Planning and Zoning Commission - Regular Meeting AGENDA

Tuesday, September 15, 2020 at 4:30 PM
Ketchum City Hall
480 East Avenue North, Ketchum, ID 83340

STAFF REPORT
KETCHUM PLANNING AND ZONING COMMISSION
MEETING OF SEPTEMBER 15, 2020

- PROJECT: 4th & Walnut Ave Commercial Development Design Review
- FILE NUMBER: P20-046
- APPLICATION TYPE: Design Review
- APPLICANT: Graham Whipple, Resin Architecture
- PROPERTY OWNER: Walnut & Fourth LLC
- LOCATION: 371 & 391 N Walnut Avenue (Ketchum Townsite: Block 44: Lots 7 & 8)
- ZONING DISTRICT: Retail Core Subdistrict of the Community Core (CC-1)
- NOTICE: The public hearing for this application was continued from the July 13th and August 11th Planning & Zoning Commission Meetings. The project was re-noticed for the public hearing scheduled on the agenda for the September 15th Planning & Zoning Commission Meeting. The public hearing notice for this project was mailed to all owners of property within 300 feet of the project site and published in the Idaho Mountain Express on August 26th, 2020.
- REVIEWER: Abby Rivin, Associate Planner

LANDSCAPING PLAN

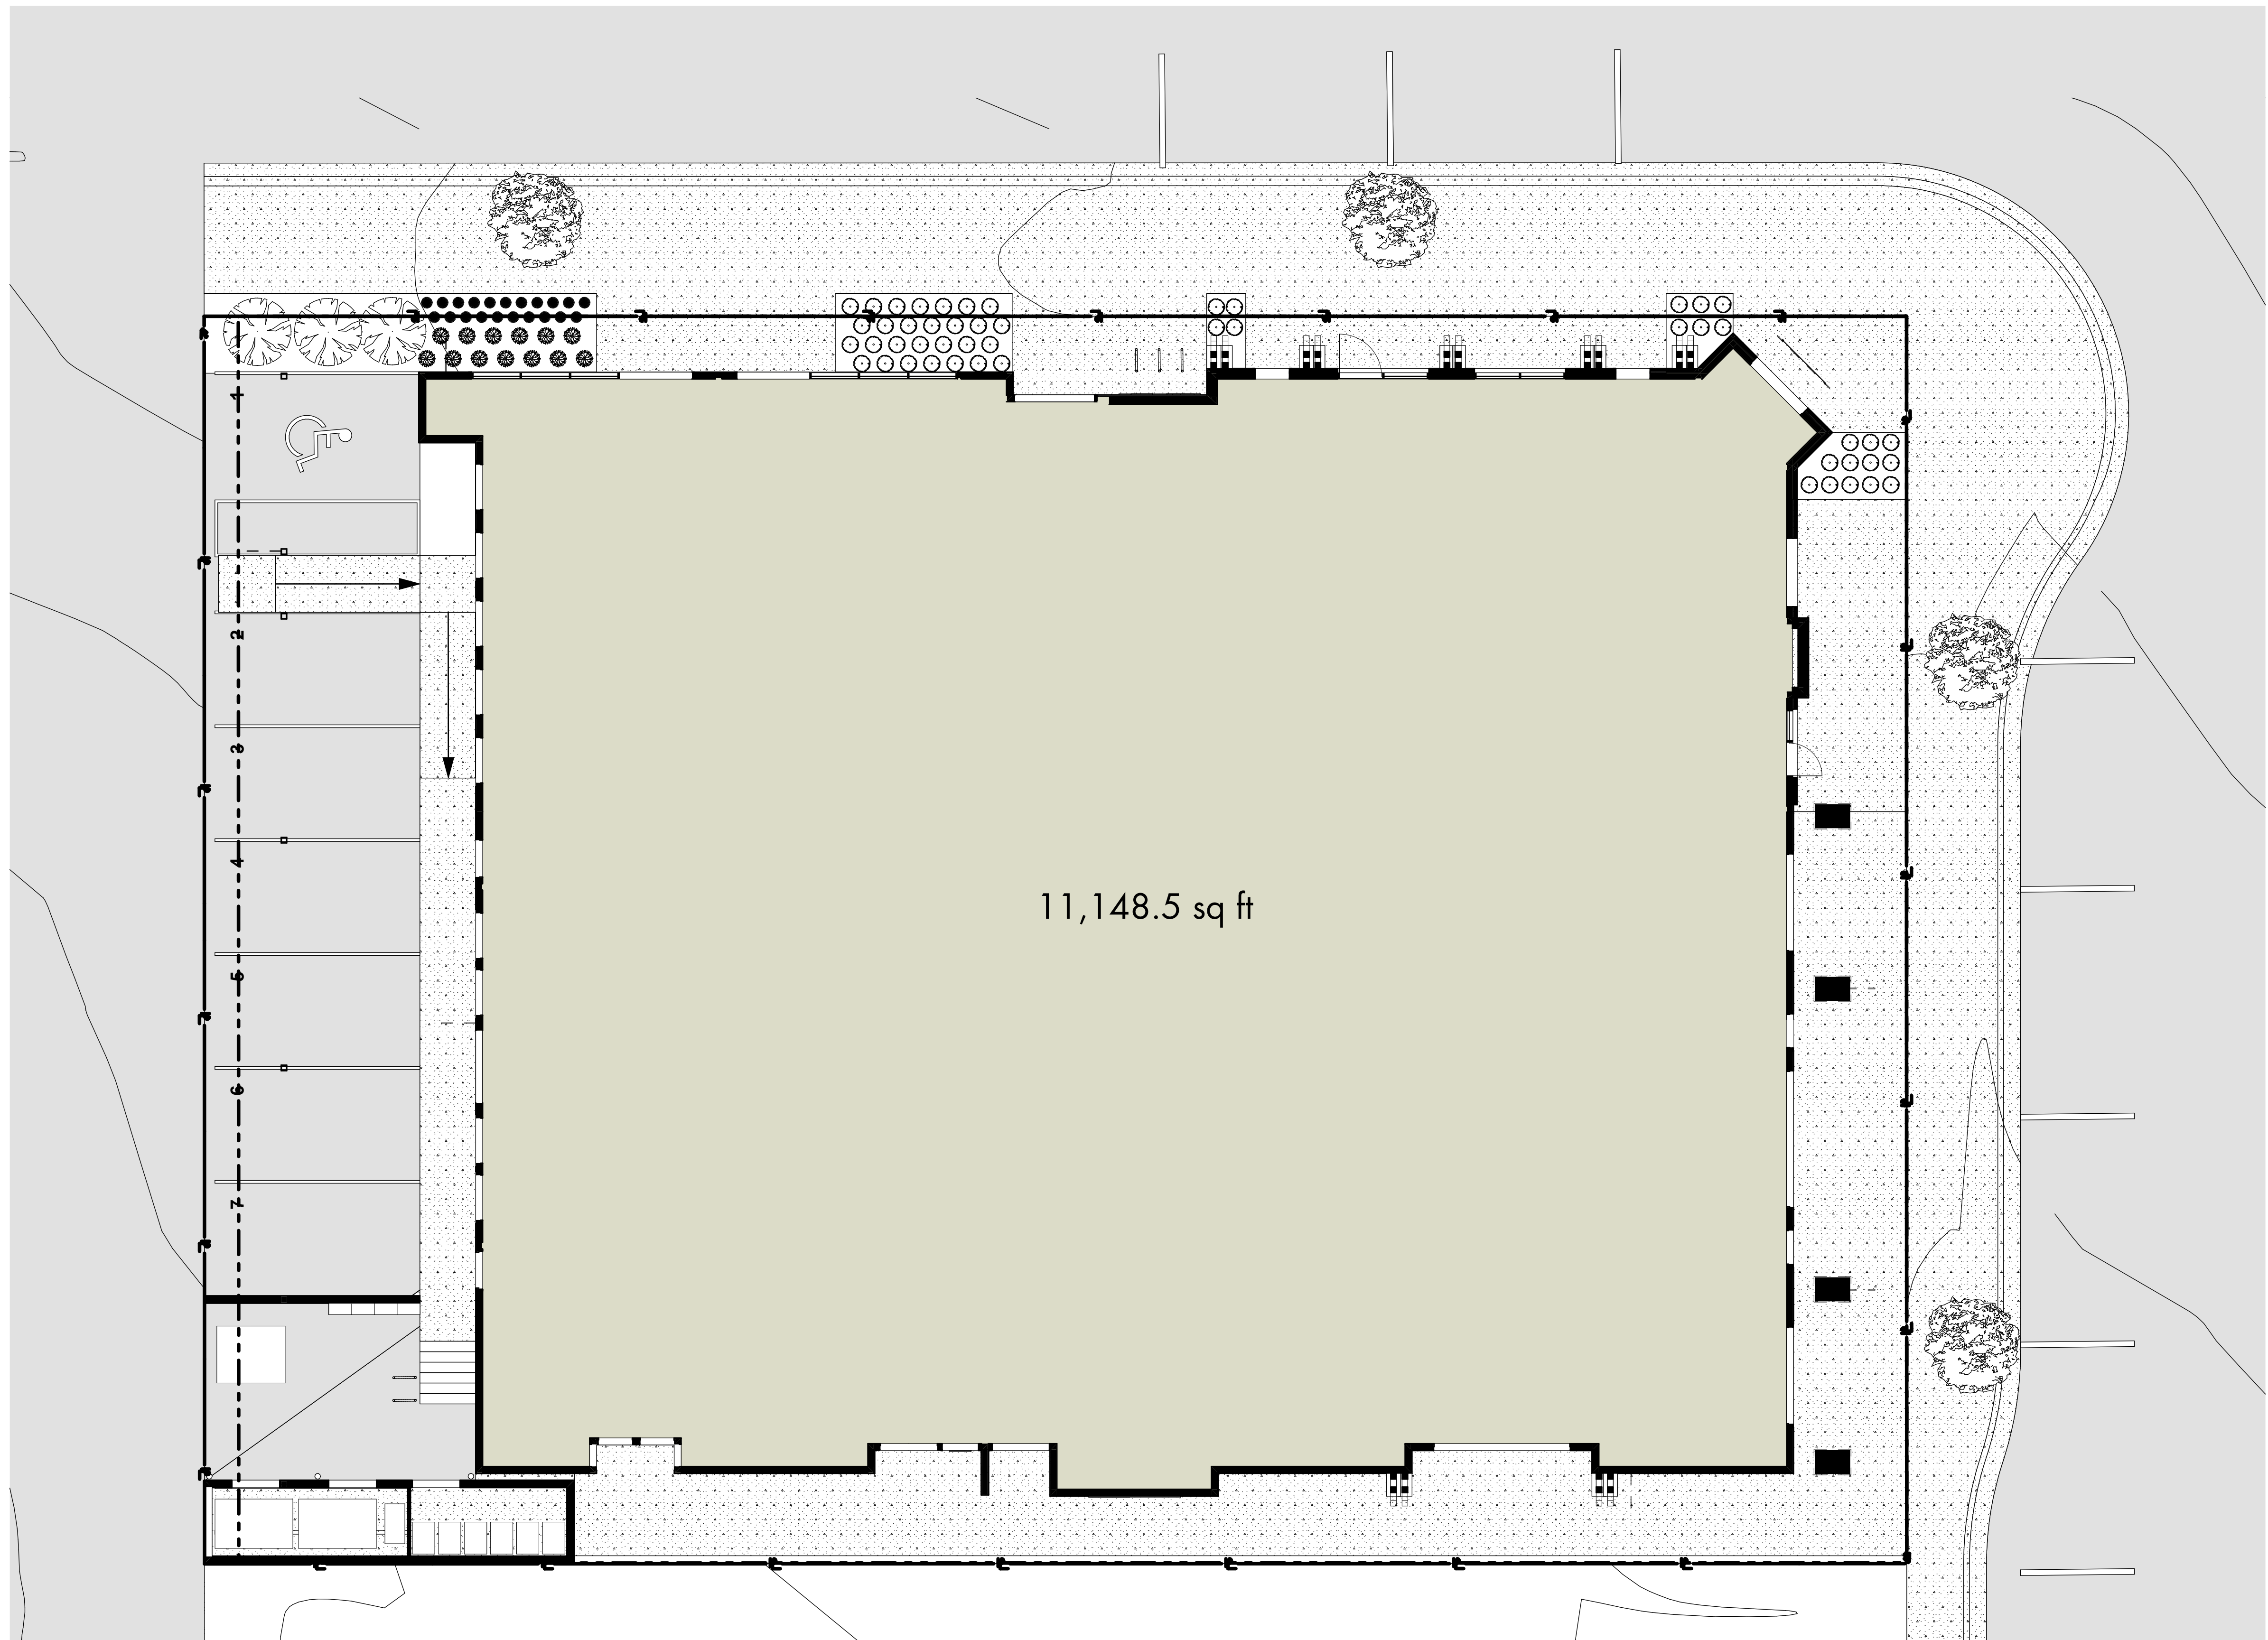
<i>Staff Comments</i>	<i>The landscape plan is indicated on sheets L-2 and L-3 of the Design Review submittal attached as Exhibit A.</i> <i>The landscape plan incorporates at-grade planters along 4th Street and Walnut Avenue. The planters will include colorful perennials and ornamental grasses that beautify the streetscape. 3 tannebaum pines are proposed on-site at the corner of 4th Street and the alley.</i> <i>The applicant has proposed four street trees within the ROW along Walnut Avenue and 4th Street. Street trees may be considered if a snowmelt system is installed for the sidewalks. Streetscape improvements must be indicated on civil plans submitted with the building permit application for final review and approval by the City Engineer and Streets Department. If approved by the City Engineer and Streets Department, all encroachments within the ROW require an Encroachment Permit.</i>

ARCHITECTURAL SITE PLAN

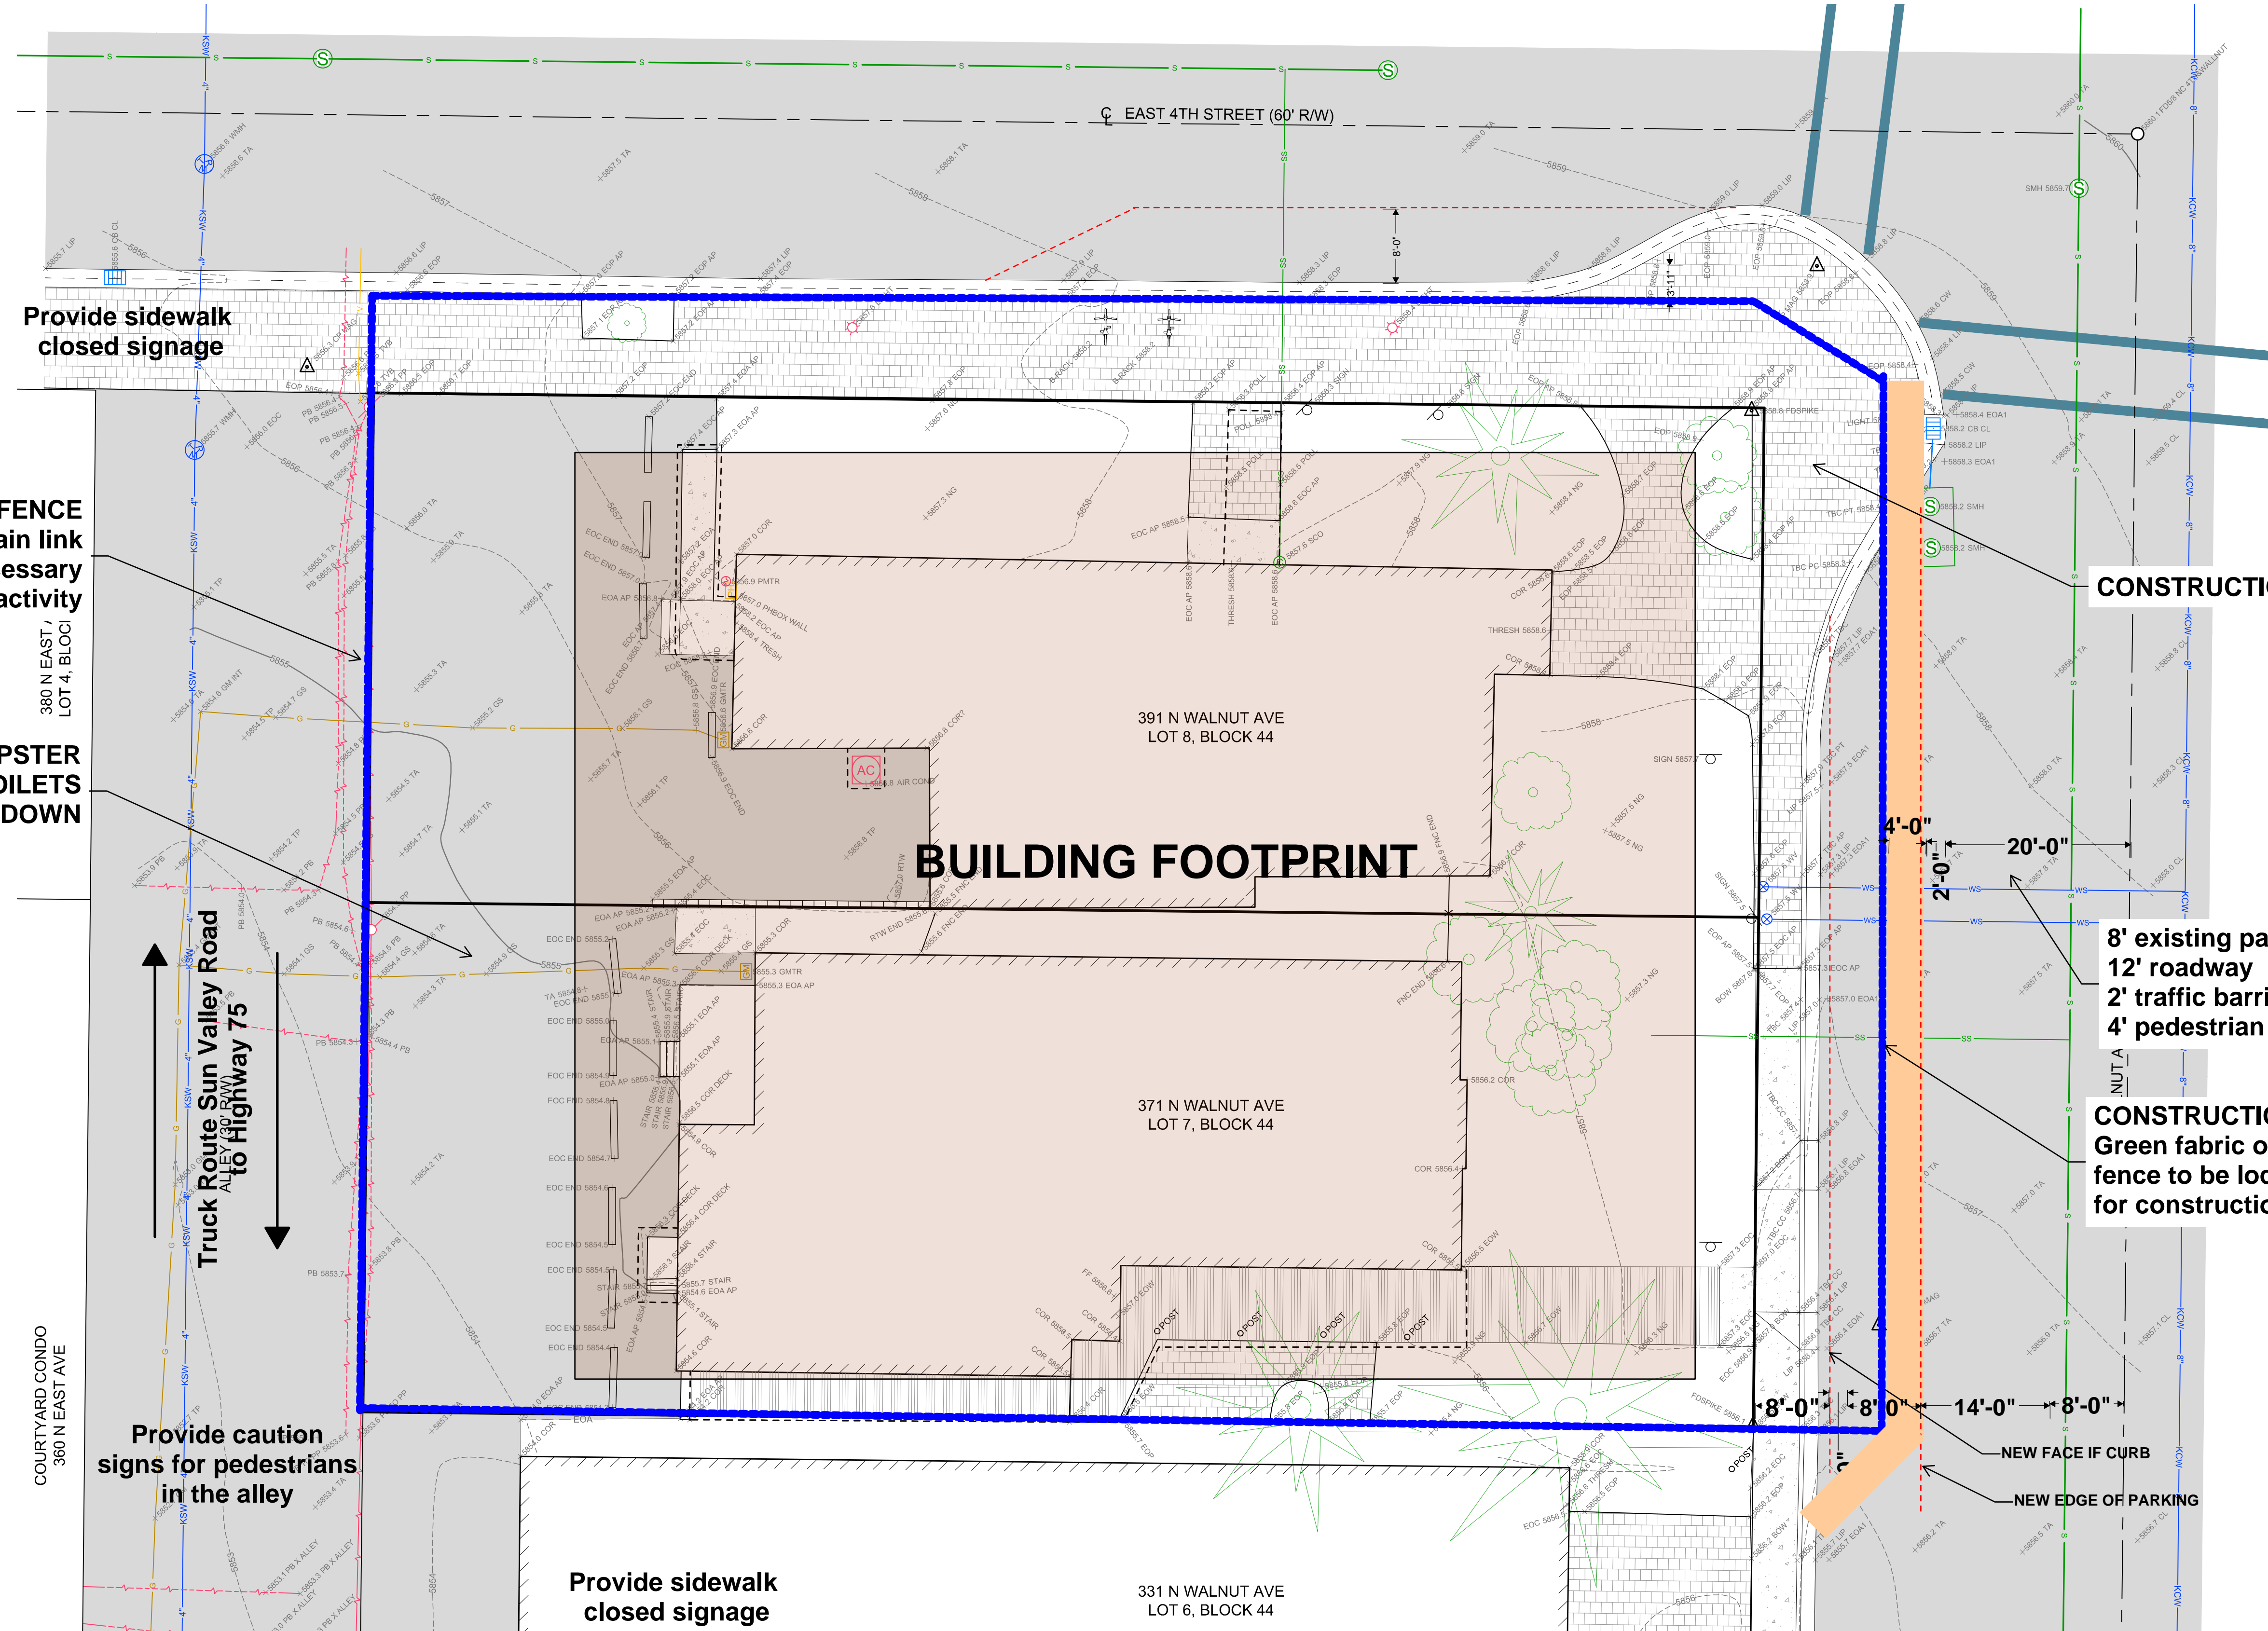
<i>Commission Findings</i>	<p><i>The Architectural Site Plan on Sheet AS-101 of the project plans note that snowmelt and hauling snow off-site is proposed in lieu of providing snow storage areas on-site.</i></p> <p><i>Most of the on-site circulation areas are covered by roof overhangs and canopies. Snow removal from the sidewalk along 4th Street and Walnut Avenue will be the responsibility of the property owner.</i></p> <p><i>The applicant proposes to snowmelt or haul snow off-site, which is permitted as an alternative to providing a snow storage area by KMC §17.96.060.H4.</i></p>
<input type="checkbox"/>	<input type="checkbox"/>	<input checked="" type="checkbox"/>	17.96.060.H2 Snow Storage	<p>Snow storage areas shall be provided on-site.</p>
			<i>Commission Findings</i>	<i>The applicant proposes to snowmelt or haul snow off-site, which is permitted as an alternative to providing a snow storage area by KMC §17.96.060.H4.</i>

1 SE Elevation
SCALE: 1/8" = 1'-0"

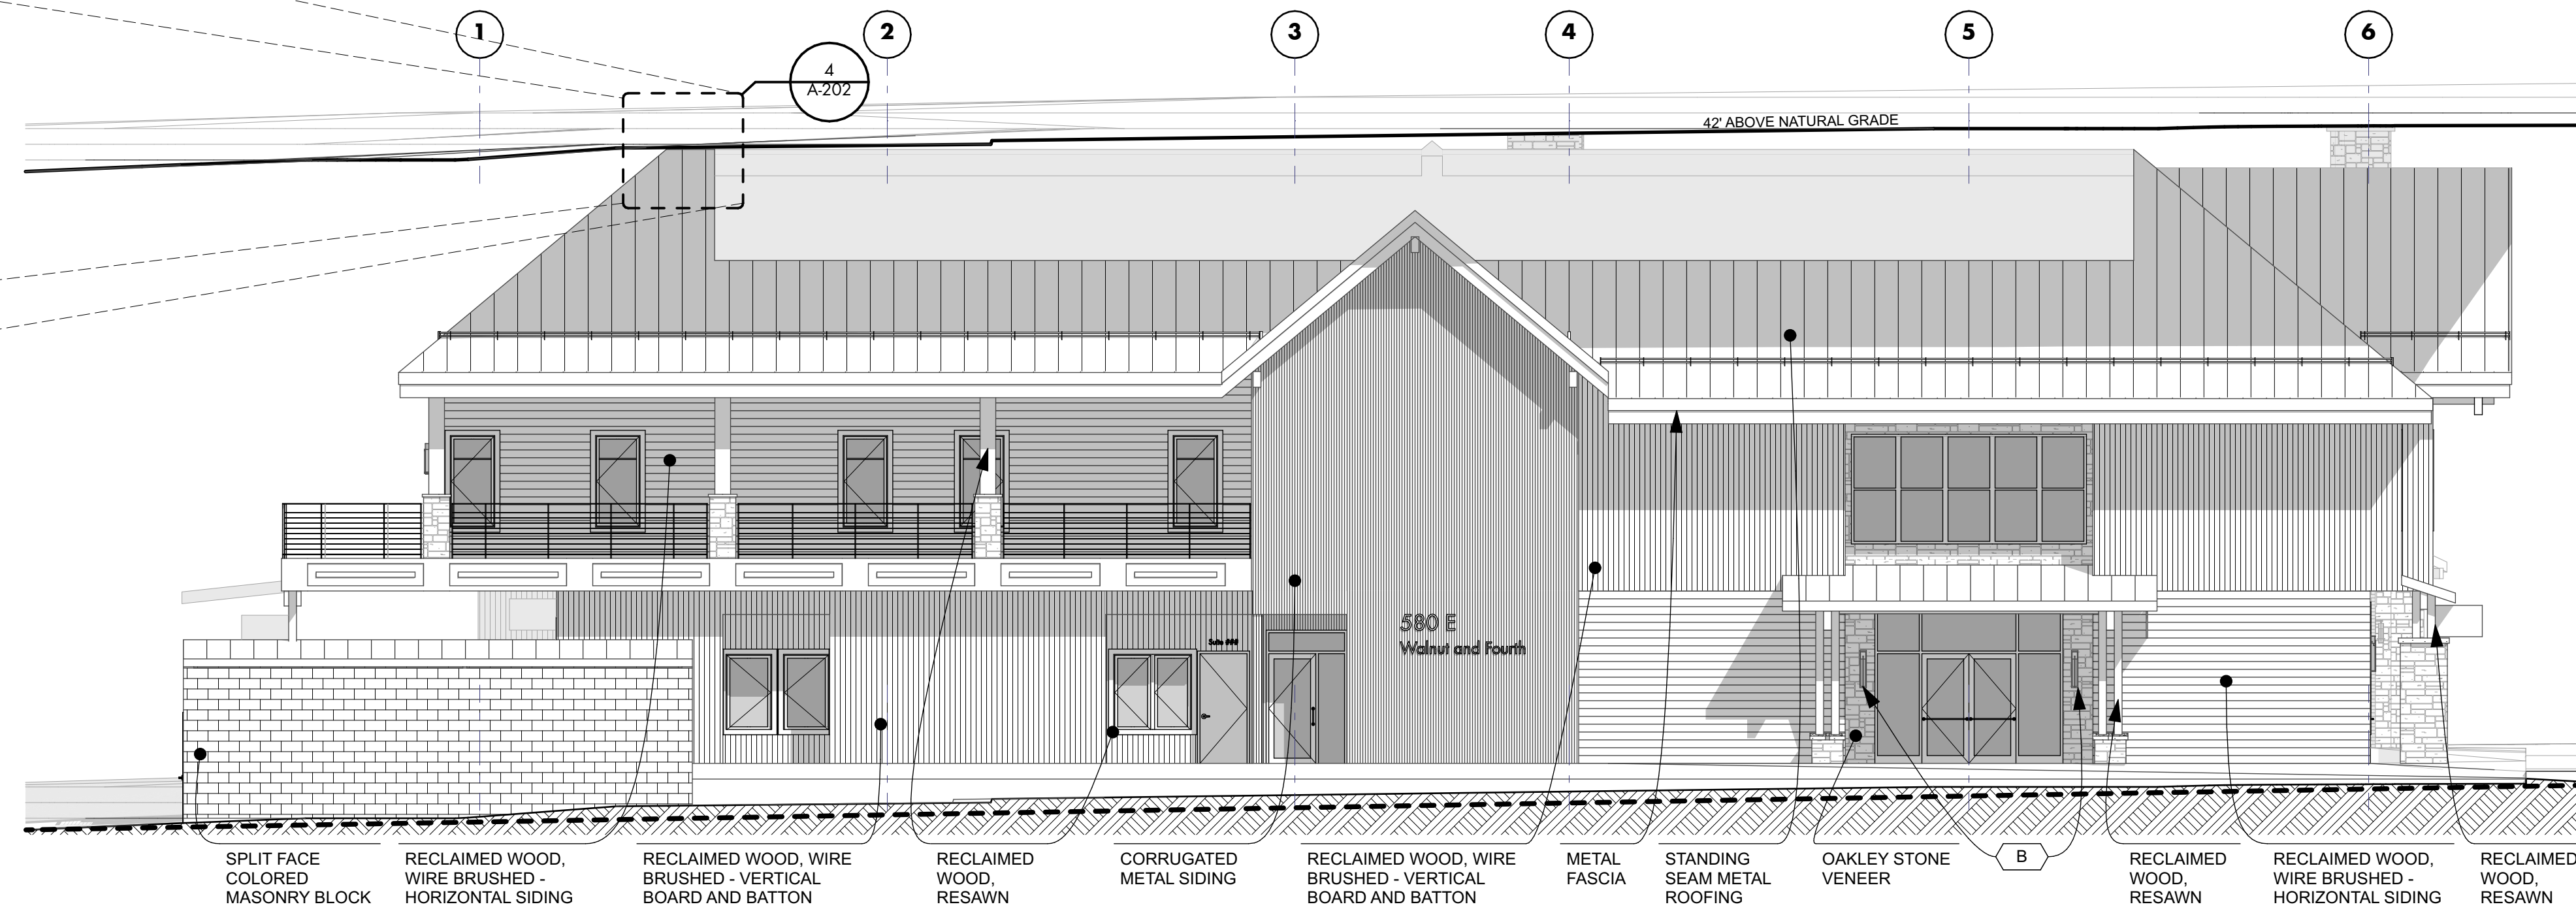
Staff Comments	<i>The proposed roof is a false mansard. As illustrated on the southeast elevation indicated on Sheet A-202, the top of the mansard roof falls into a 10-foot deep recessed area that is fully screened from public view. All roof-mounted mechanical, plumbing, and electrical</i>
